SUBJECT: Revised Preliminary Subdivision Plan Approval for the single-family residential Open Space Conservation Subdivision known as the Reserve at River Oaks, Phases I-V.

PC Case No: 2018-5349

RE: The Reserve at River Oaks Subdivision – Phase 4
Revised Exhibit and Engineers Estimate

Date: December 3, 2018
To: Kris McMaster, City Planner
C: Greg Hannan, Director of Community Development
From: Bradley Kosco PE., PS., City Engineer
Re: **Reserve at River Oaks Phase 4 – Revised Cost Estimates for Proposed Waterline and Path Improvements**

THE RESERVE AT RIVER OAKS EXPANDED PRELIMINARY PLAN RE-APPROVAL

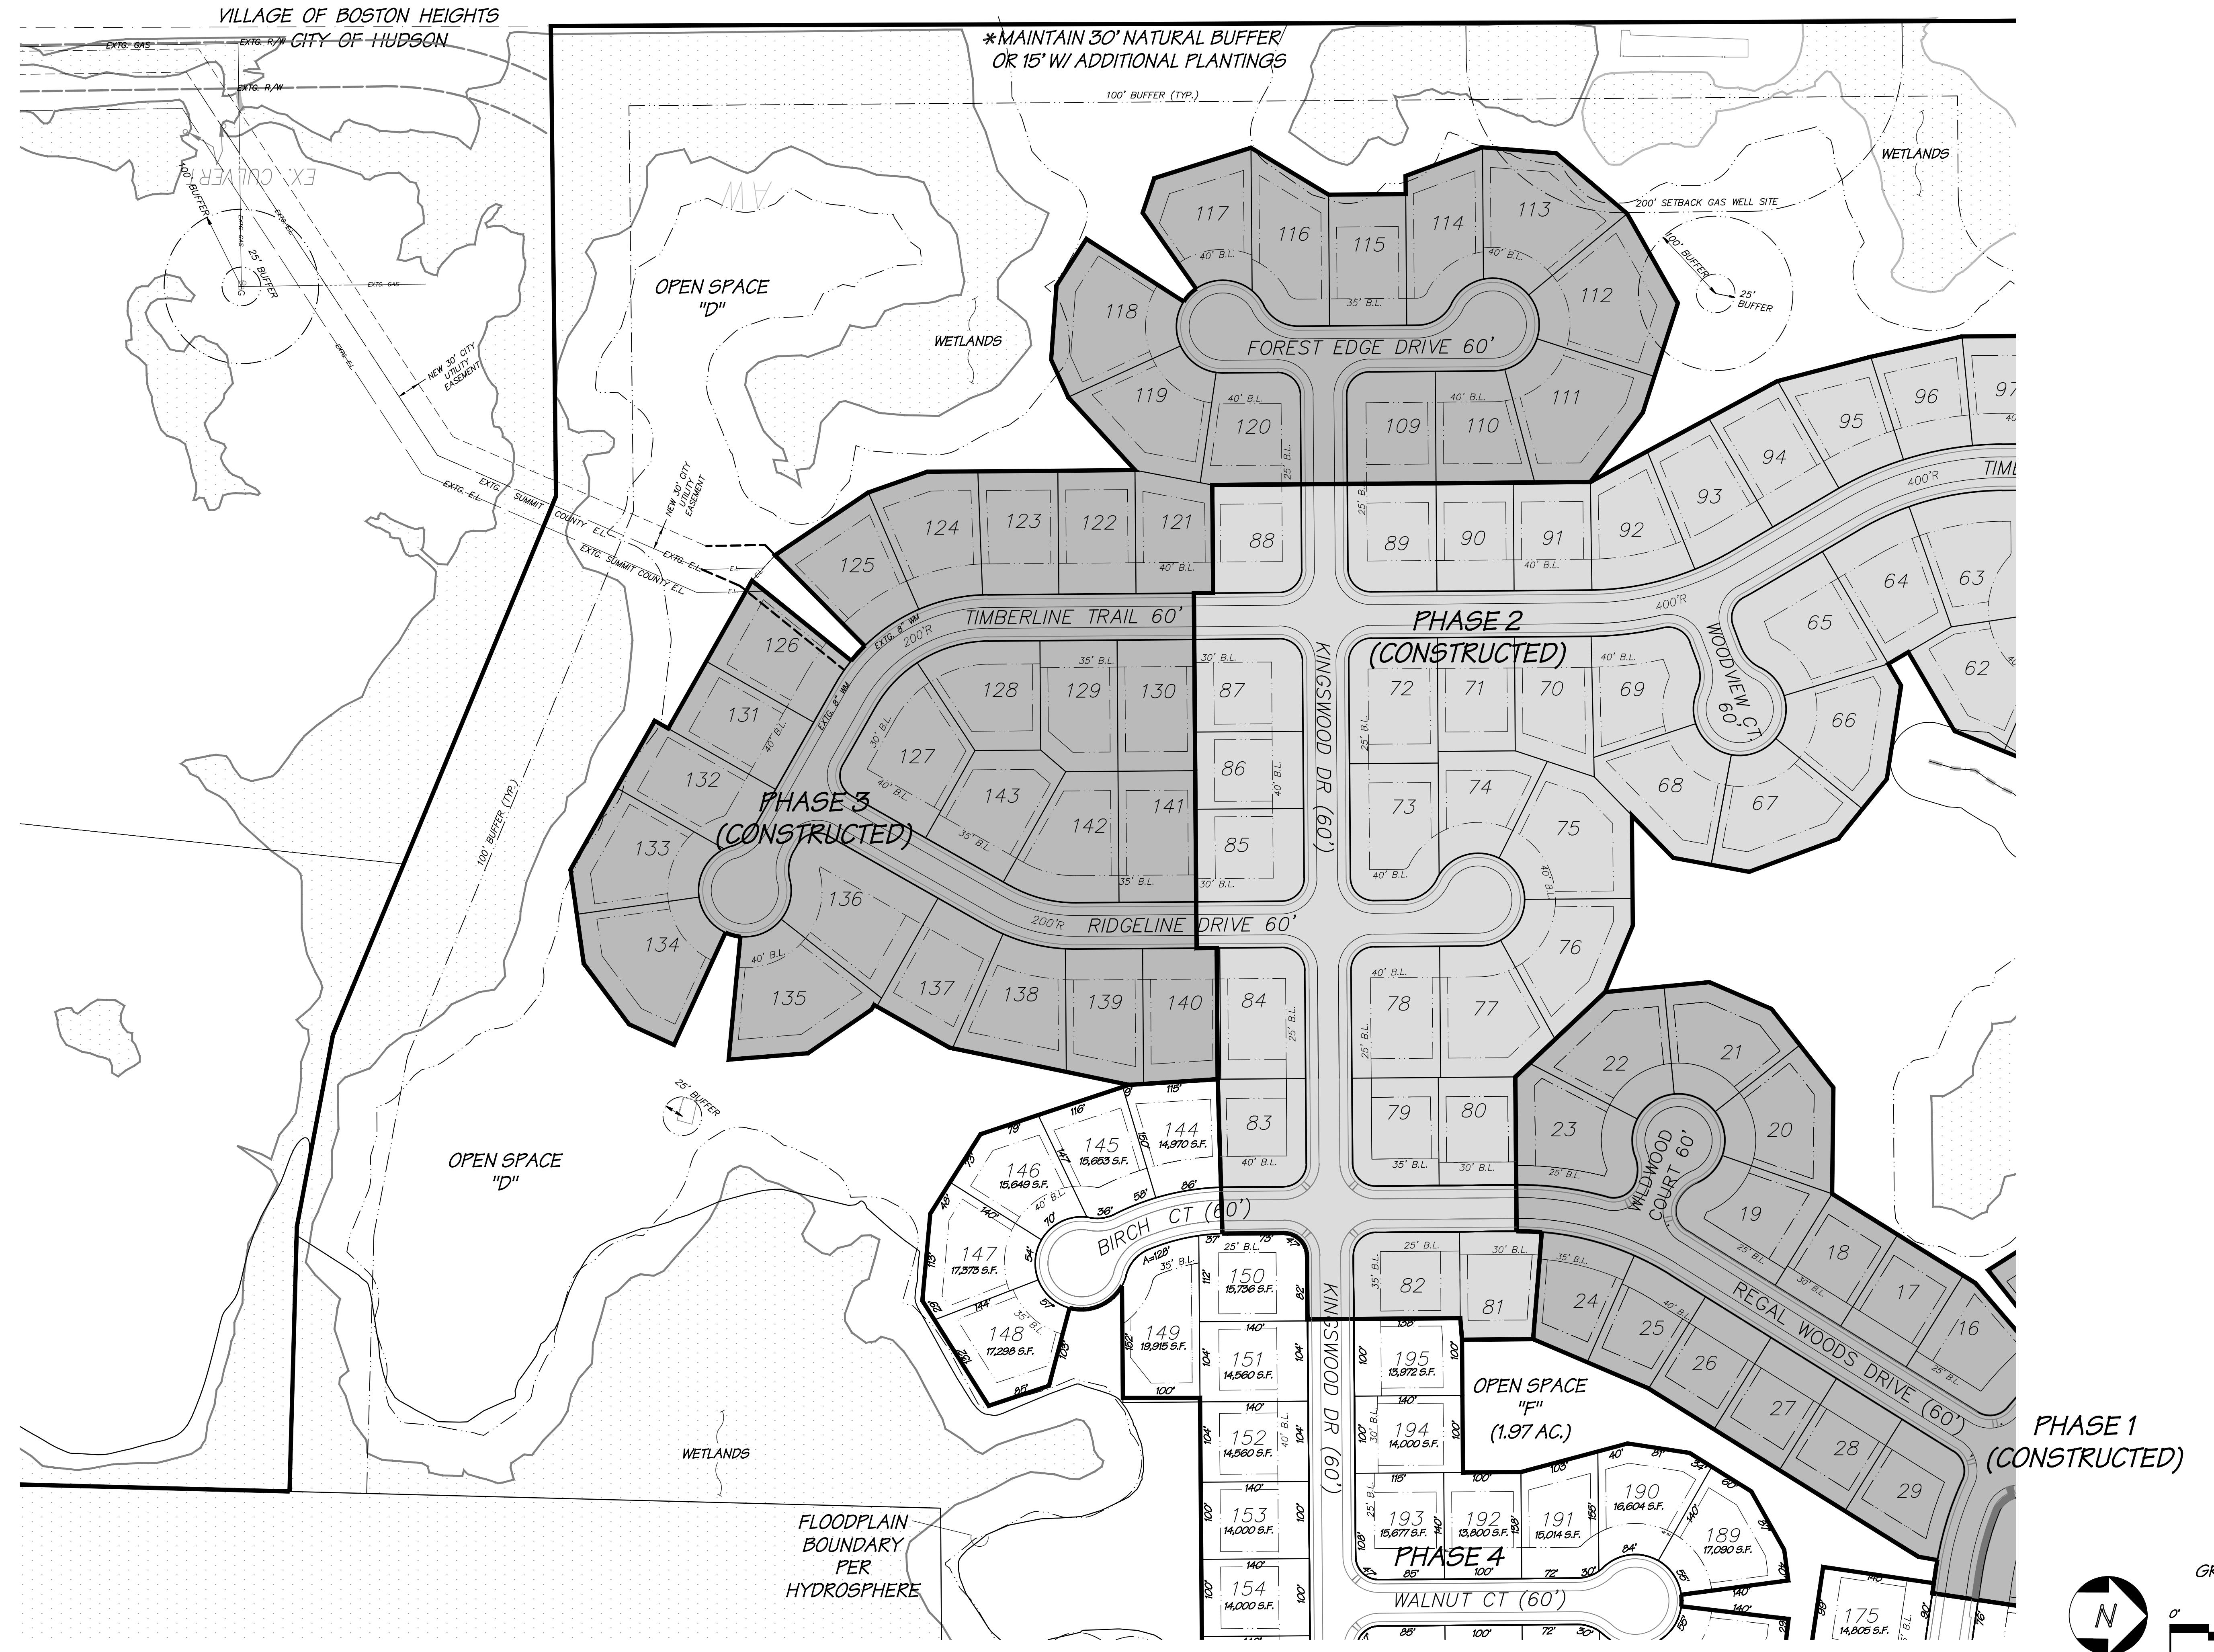
- f. Pedestrian Linkage and Pathways: The plans submitted are acceptable provided the applicant indicates how the existing widened 8-foot walkway will transition to a 5-foot sidewalk for Phase IV.

1. Plans must be revised to show the following:
 - a. Submit final subdivision plans for future phases.
 - b. Verify the Wetland documentation is still valid.
 - c. Indicates how the existing widened 8-foot walkway will transition to a 5-foot sidewalk for Phase IV.
 - d. Applicant to submit a cash amount of \$625,610.94 as payment in lieu to comply with the required public open space and utility requirement. City of Hudson will utilize the submitted funds to complete the utility installation and to apply the trail funds toward a larger trail development project along Boston Mills Road.
